AR8200 SERIES II - hand portable radio receiver ADDENDUM (paperwork V1.0)

Due to continuous development of our products, the *AR8200 SERIES II* has been developed which differs from the original AR8200 in a few areas, please note the following changes to the AR8200 operating manual:

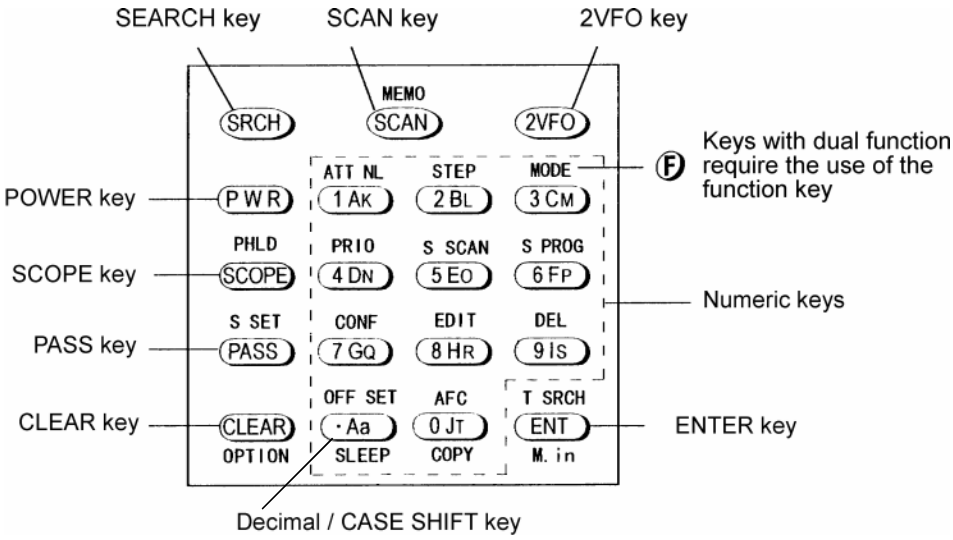
1 The front 'ten-key' keypad has been rearranged in line with customer requests placing the '0' zero key underneath the '8' eight key as standard practice with push button telephones. On page 9 section 1-5-1 of the English language operating manual, the graphic should now look like:
